PD Modification Application: PRS 24-0104

**Hillsborough
County Florida**

Development Services Department

AGENCY REVIEW COMMENT SHEET

Figure 3 - Proposed Typical Section

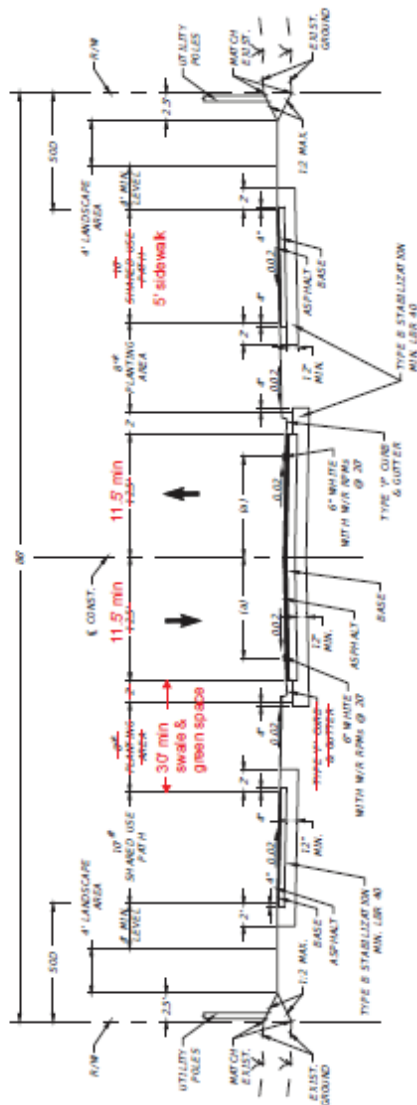
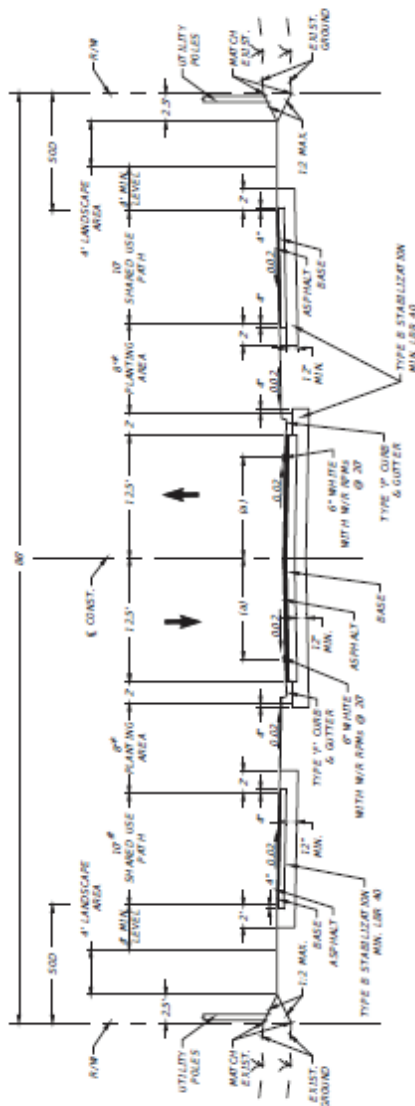
This request is a design exception to the Hillsborough County Transportation Technical Manual for a portion of Summerfield Crossing Blvd from its intersection with Queens Town Dr & Candle Stick Ln at the south end to its intersection with US 301 S as shown in **Figure 2**. The requested exceptions to the C3-2U typical section and justifications are as follows:

- The C3-2U typical section requires a minimum pavement width of 12.5-ft from road centerline to edge of pavement.
 - This request is to maintain the existing travel lanes and pavement width which varies from 11.5 feet to 12.5 feet in this portion of the roadway. It is my recommendation that the existing width be maintained as the addition of only up to a foot of additional pavement is not a meaningful safety improvement.
- The C3-2U typical section requires a type F curb at edge of pavement and 8' planting area between the back of curb and shared use path along both sides of the roadway.

- This request is to maintain the existing swale/green space along the west side of the roadway in place of the type F curb and 8' planting area and to maintain the existing type F curb on the east side of the roadway. The existing swale/green space between the roadway and shared use path provides adequate separation for pedestrians which would not be substantially improved by the addition of curbing. The entire road width slopes towards the swale which is used as the primary drainage feature for this portion of the road. The installation of the typical curb on the west side of the road would reduce the capacity of the existing swale which is 1.5-ft deep with no bottom width versus the minimum typical swale size of 2.5-feet deep and 4-ft bottom width. It is my recommendation that a type F curb not be installed on the western edge of pavement given the potential impact to drainage capacity and lack of significant safety improvement it would provide.

- The C3-2U typical section requires a 10-ft shared use path along both sides of the roadway.
 - This request is to maintain the existing 10-ft shared use path along the west side of the roadway, maintain existing 5-ft sidewalk along the east side of the roadway, and to provide a 5-ft sidewalk along the east side of the roadway where not currently present. Existing utilities and width of available ROW do not allow for the installation of a 10-ft shared use path and as such, a 5-ft sidewalk to close the gap between existing facilities is a reasonable safety improvement. The gap between existing 5-ft sidewalk on the east side of the roadway is approximately 1,030 feet long; however, the available ROW width outside the roadway is unclear for roughly 310 feet at its northern end. It is my recommendation that a 5-ft sidewalk be installed along the east side of the road to close the gap between existing facilities where available ROW allows. Survey should be completed to confirm the actual available ROW width.

A marked up version of the C3-2U typical section with the proposed details is provided in **Figure 3**.

Figure 3 - Proposed Typical Section

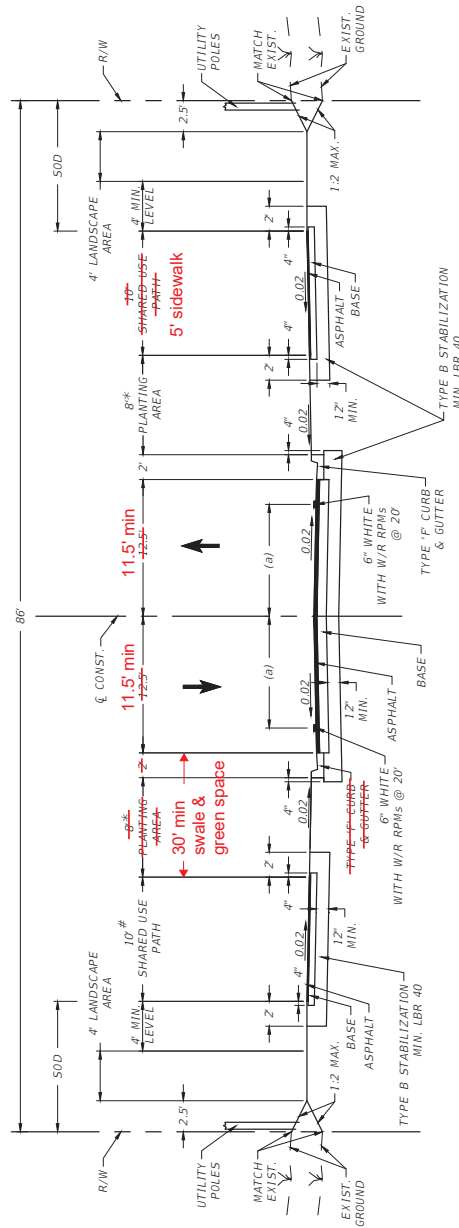
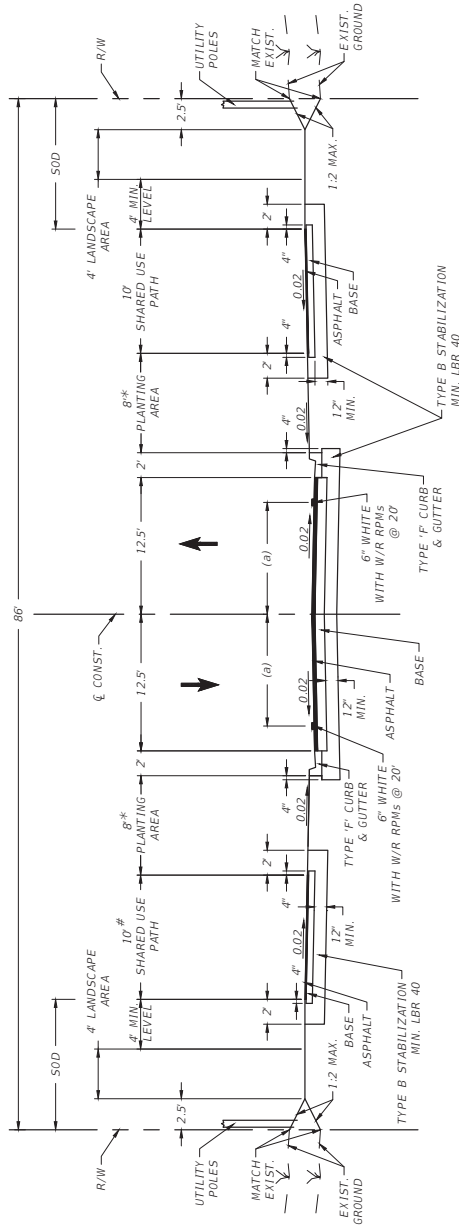
This request is a design exception to the Hillsborough County Transportation Technical Manual for a portion of Summerfield Crossing Blvd from its intersection with Queens Town Dr & Candle Stick Ln at the south end to its intersection with US 301 S as shown in **Figure 2**. The requested exceptions to the C3-2U typical section and justifications are as follows:

- The C3-2U typical section requires a minimum pavement width of 12.5-ft from road centerline to edge of pavement.
 - This request is to maintain the existing travel lanes and pavement width which varies from 11.5 feet to 12.5 feet in this portion of the roadway. It is my recommendation that the existing width be maintained as the addition of only up to a foot of additional pavement is not a meaningful safety improvement.
- The C3-2U typical section requires a type F curb at edge of pavement and 8' planting area between the back of curb and shared use path along both sides of the roadway.

- This request is to maintain the existing swale/green space along the west side of the roadway in place of the type F curb and 8' planting area and to maintain the existing type F curb on the east side of the roadway. The existing swale/green space between the roadway and shared use path provides adequate separation for pedestrians which would not be substantially improved by the addition of curbing. The entire road width slopes towards the swale which is used as the primary drainage feature for this portion of the road. The installation of the typical curb on the west side of the road would reduce the capacity of the existing swale which is 1.5-ft deep with no bottom width versus the minimum typical swale size of 2.5-feet deep and 4-ft bottom width. It is my recommendation that a type F curb not be installed on the western edge of pavement given the potential impact to drainage capacity and lack of significant safety improvement it would provide.

- The C3-2U typical section requires a 10-ft shared use path along both sides of the roadway.
 - This request is to maintain the existing 10-ft shared use path along the west side of the roadway, maintain existing 5-ft sidewalk along the east side of the roadway, and to provide a 5-ft sidewalk along the east side of the roadway where not currently present. Existing utilities and width of available ROW do not allow for the installation of a 10-ft shared use path and as such, a 5-ft sidewalk to close the gap between existing facilities is a reasonable safety improvement. The gap between existing 5-ft sidewalk on the east side of the roadway is approximately 1,030 feet long; however, the available ROW width outside the roadway is unclear for roughly 310 feet at its northern end. It is my recommendation that a 5-ft sidewalk be installed along the east side of the road to close the gap between existing facilities where available ROW allows. Survey should be completed to confirm the actual available ROW width.

A marked up version of the C3-2U typical section with the proposed details is provided in **Figure 3**.
